# DRAINAGE REPORT

**CE WELL PAD**

MERRICK RESPONSES  
IN GREEN

STORMWATER  
Reviewed by: SLS  
January 5, 2023

MRG, LP OIL AND GAS CE PAD  
 CITY OF LOVELAND, COLORADO  
 CE DRAINAGE MAP  
 DRILLING PHASE

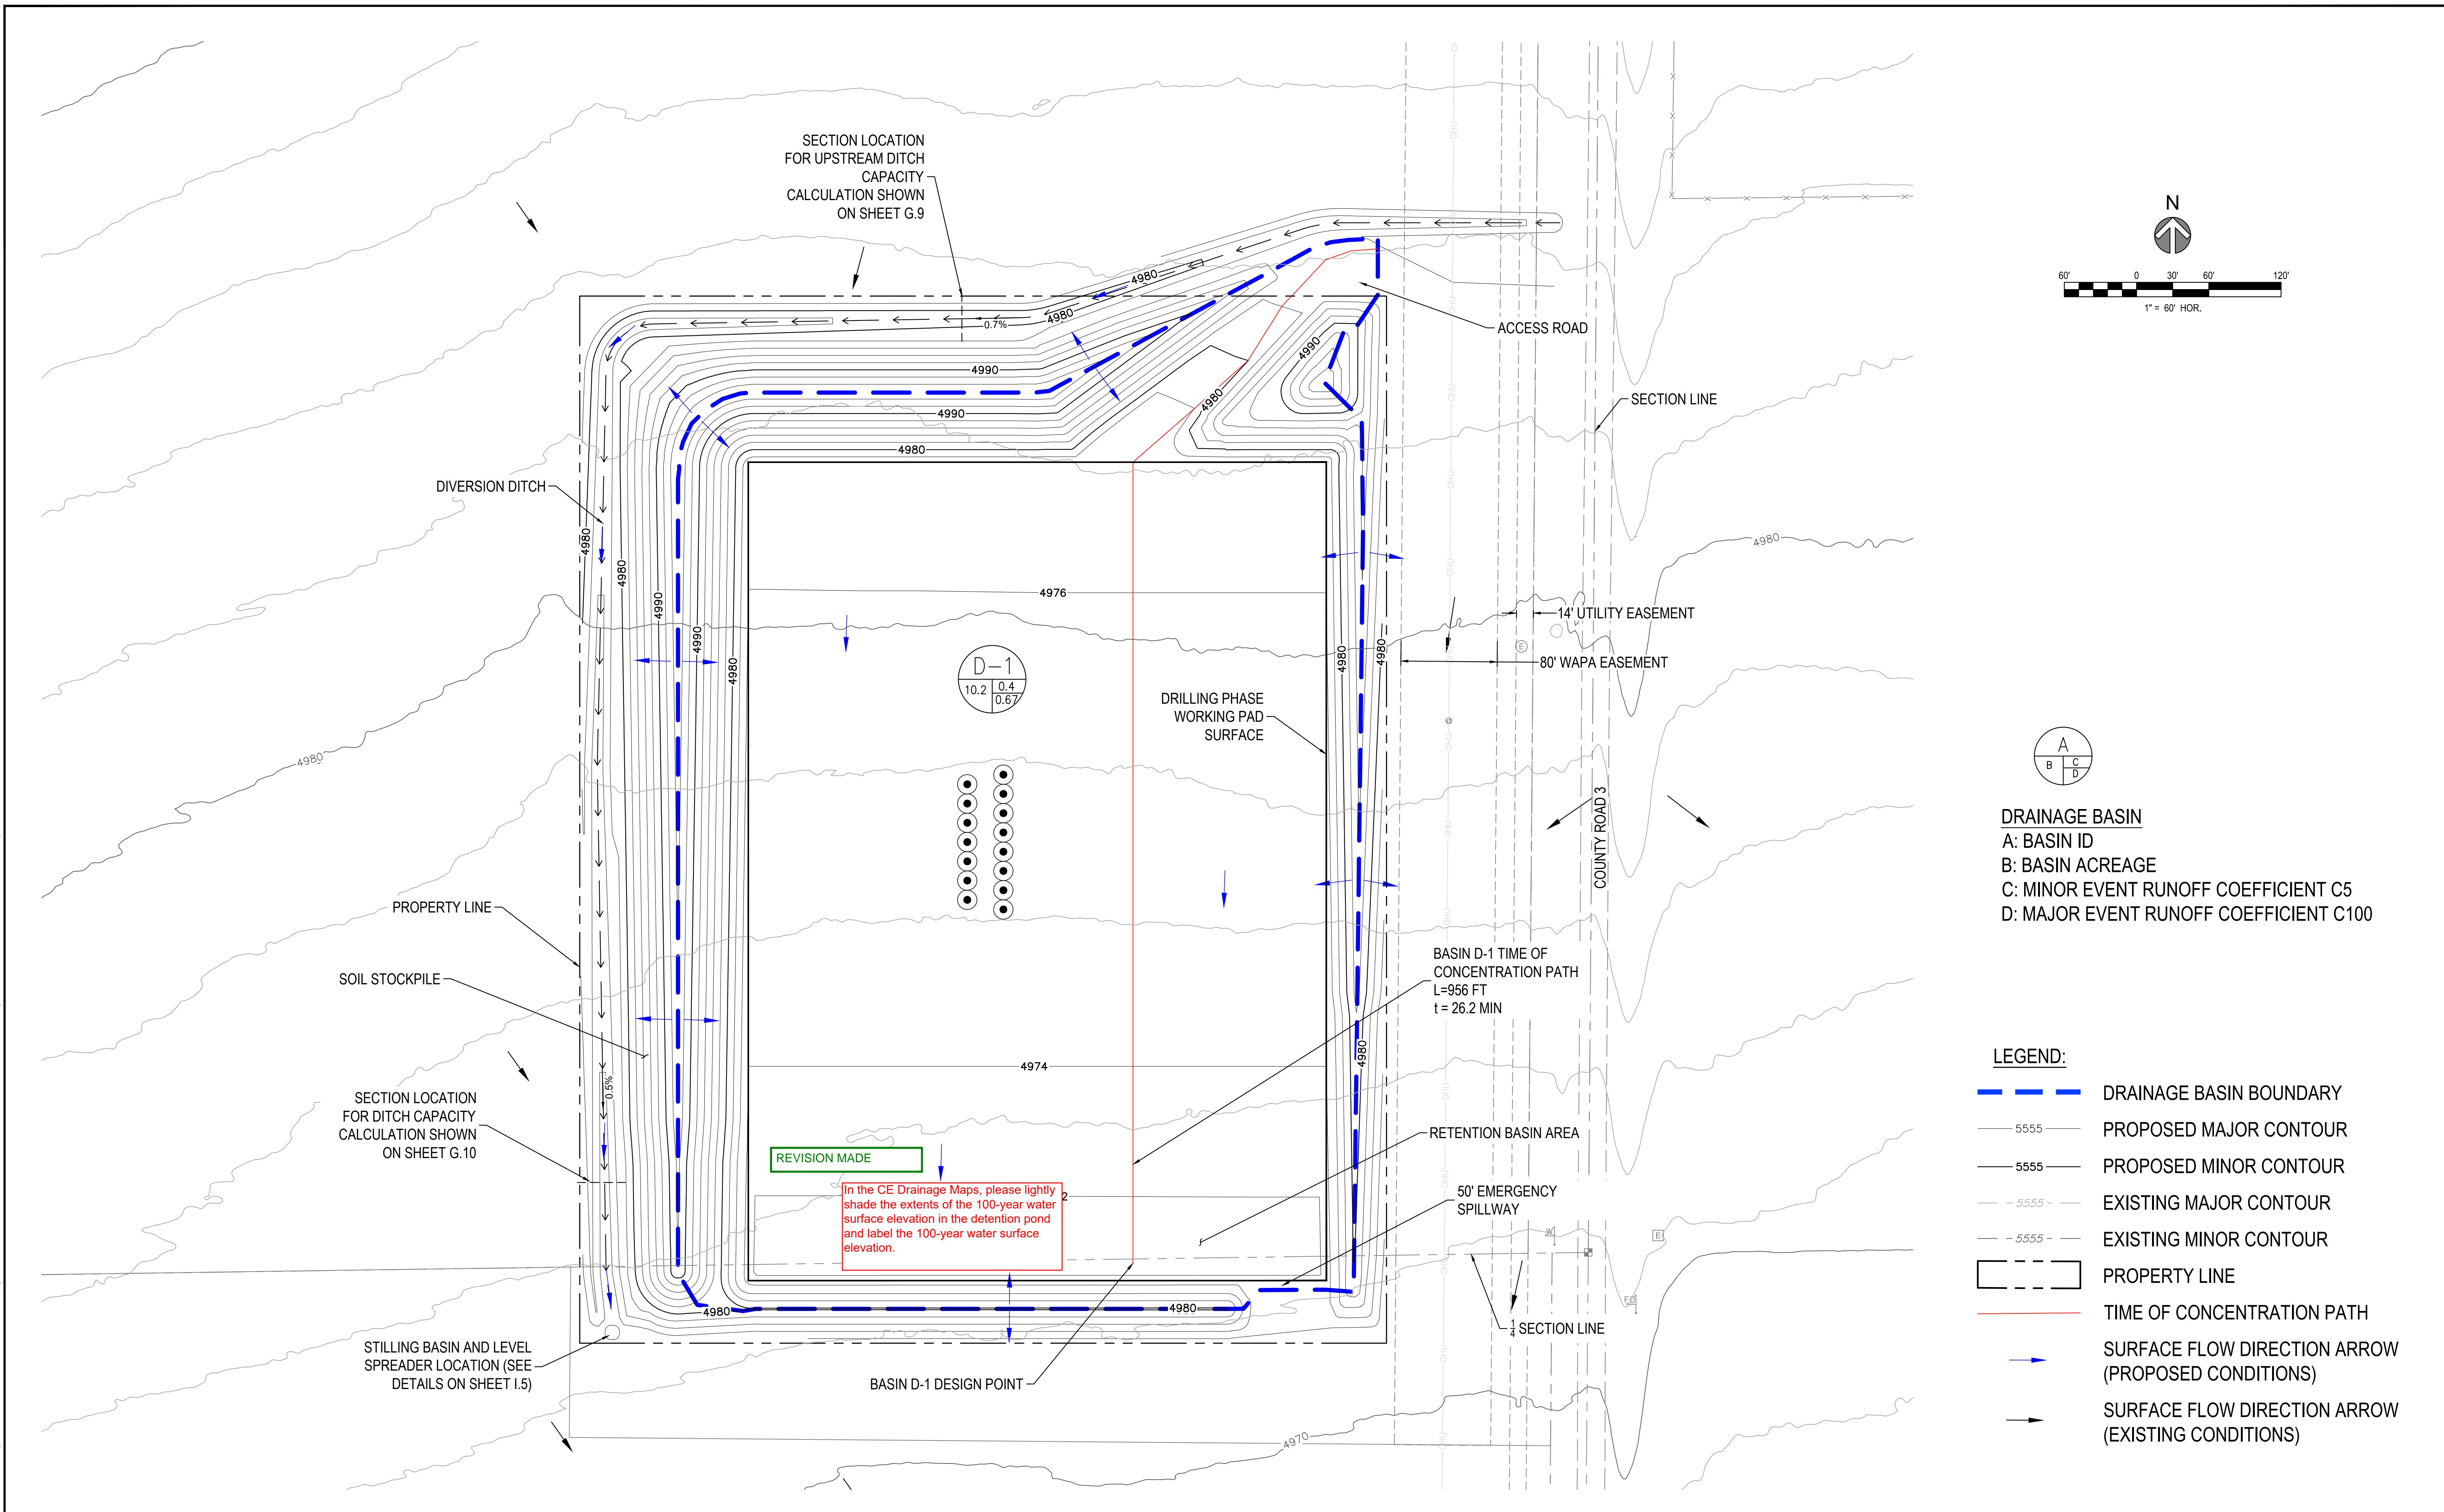
Per our criteria, the detention pond volume needs to be sized to detain rainfall from a two-hour 100-year storm event. Therefore, please increase the rainfall duration in the "Detention Volume by the Modified FAA Method" to 120 minutes.

Please provide a stage-storage calculation sheet to show the various water elevations that are designed within the detention pond in the drilling and production phases.

**REVISED TO DETAIN 150% OF TWO-HOUR 100-YEAR STORM EVENT.**

**STAGE-STORAGE TABLES PROVIDED IN APPENDICES.**
